Finger 2336713-2 and 2329497-2 Label issue

Finger 2329497-1 & 2336713-1 is dedicate for H customer and has special label requirement. Please apply PN 2329497-2 & 2336713-2 for general customer.

Finger 2336713-1 Intermediate label

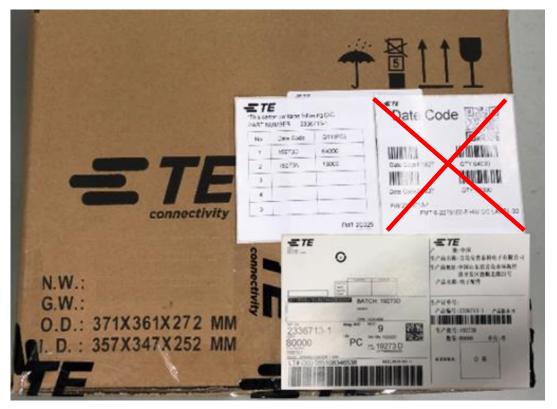
Cancel H customer label.
